MEMORANDUM

DATE: January 23, 2018

SUBJECT: Office of Planning Report for Large Tract Review Case No. 2017-03
415 14th Street SE (Square 1042, Lot 109)

Figure 2 – Commercial Truck Turning Analysis (Source: Wells & Associates, CTR Appendix I, 8/21/17)

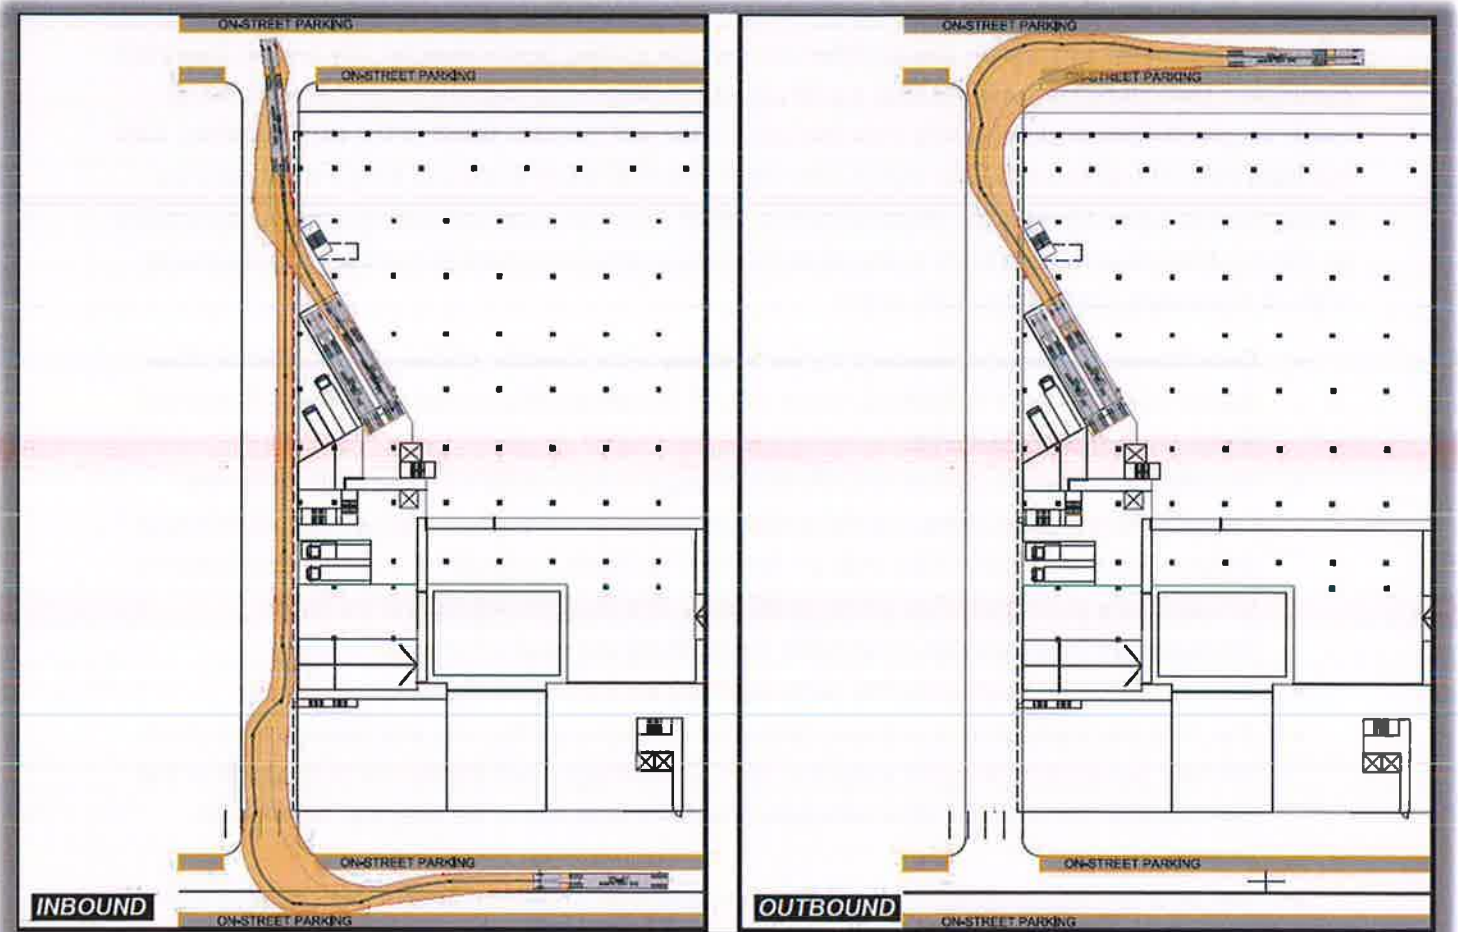
Additionally, based on the truck turning diagrams submitted by the Applicant (Figure 2), one or two on-street vehicle parking spaces on the south side of D Street SE just east of the alley may need to be removed to accommodate the larger grocery delivery trucks. DDOT finds this acceptable in order to facilitate orderly head-in/head-out truck maneuvers from the alley.

- ANC 6B is concerned about **turning diagrams for the north end of the alley**. While the proposed alley design is a major improvement, the turning diagrams show that under the current design some trucks will need to cross public space (the sidewalk) and then reverse into the loading bays. A major problem with the current Safeway configuration is that it requires trucks to cross and then reverse across sidewalks, and we would prefer a design that avoids sidewalk crossings.

- Implement the loading management plan proposed in the 8/21/17 CTR and listed later in this report to mitigate larger trucks backing down the alley to access the diagonally-configured grocery store loading berths;
- Implement the TDM plan proposed in the 8/21/17 CTR and listed later in this report.
- Implement the ZR16-required TDM mitigations, as noted above, in quantities to be determined by the Zoning Administrator;
- Construct ADA ramps at the following locations:
 - Northwest corner of D Street and Kentucky Avenue SE;
 - Northwest corner of Pennsylvania Avenue and 11th Street SE; and
 - Northwest corner of Pennsylvania Avenue and 12th Street SE.

Figure 3 – Site Plan and Public Space Design (Source: Applicant Plan Submission, Page 20, 4/13/17)

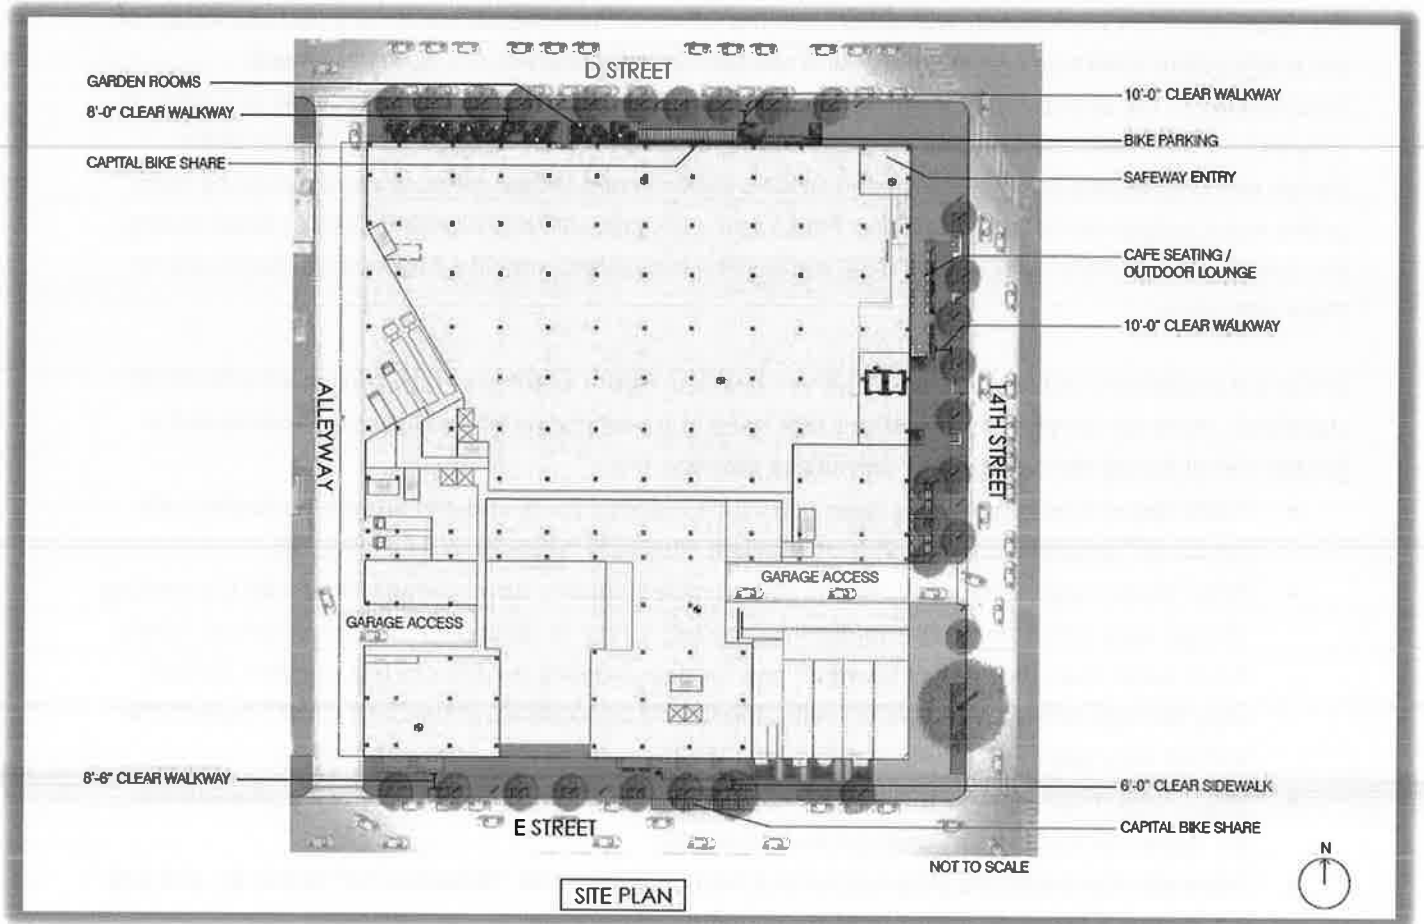
While the preliminary public space plans, shown below in Figure 3, are generally consistent with DDOT standards, there are several considerations that need to be incorporated and items to be reviewed in greater detail during the public space permitting process:

Figure 4 – Proposed Combined Curb Cut on 14th Street SE (Source: Wells & Associates, Supplemental Figure 6, 11/14/17)

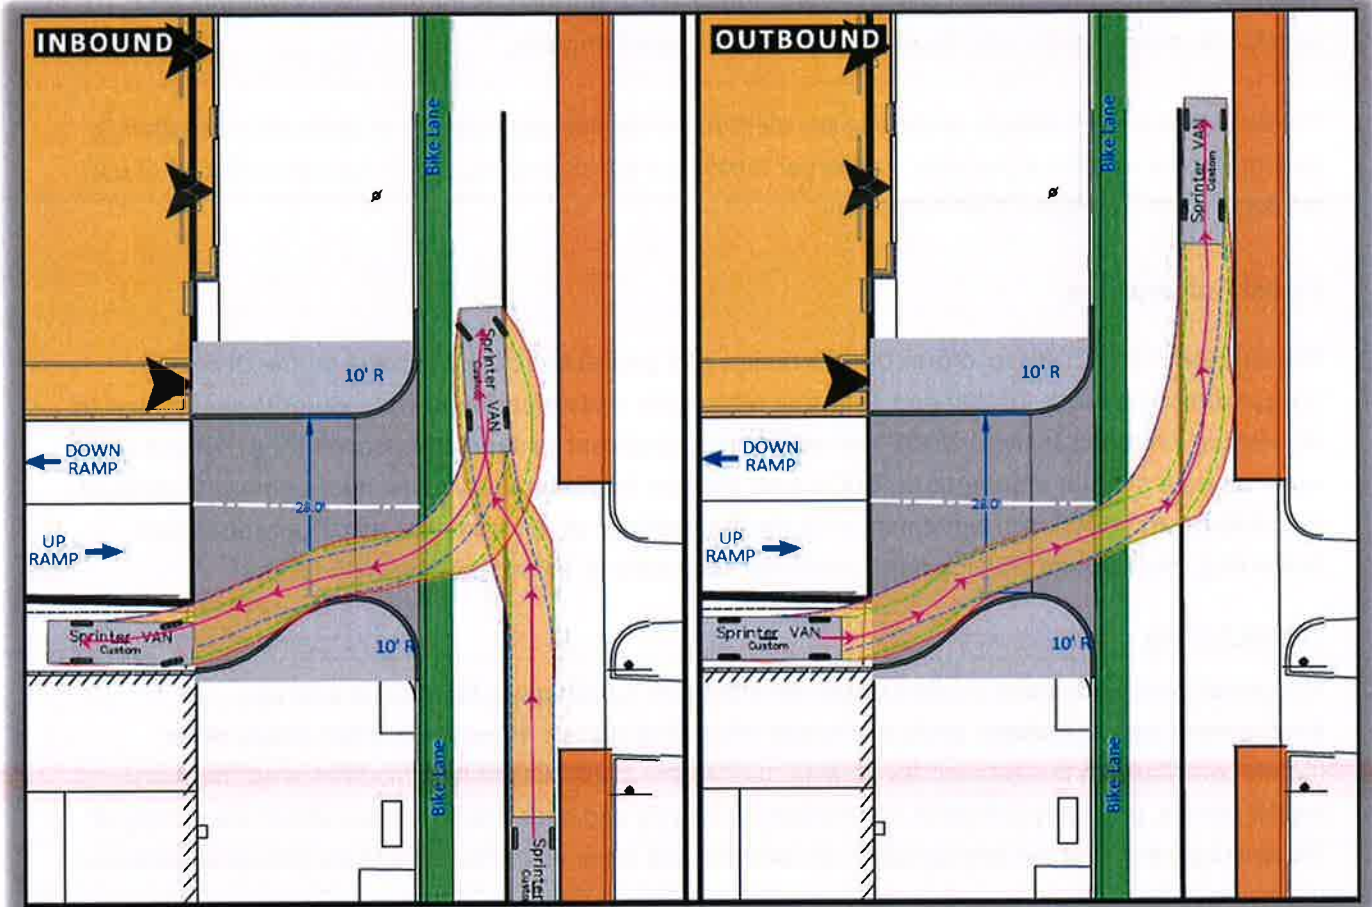
- DDOT finds it appropriate to combine the proposed grocery store entrance/exit with the existing 10-foot alley into a single 28-foot curb cut on 14th Street SE (as shown in Figure 3 below). While this is wider than the 24-foot standard and requires backing in or out of the adjacent 10-foot alley through public space, this is preferable to two curb cuts close together. DDOT expects the 10-foot alley will be eliminated when and if the property to the south redevelops;
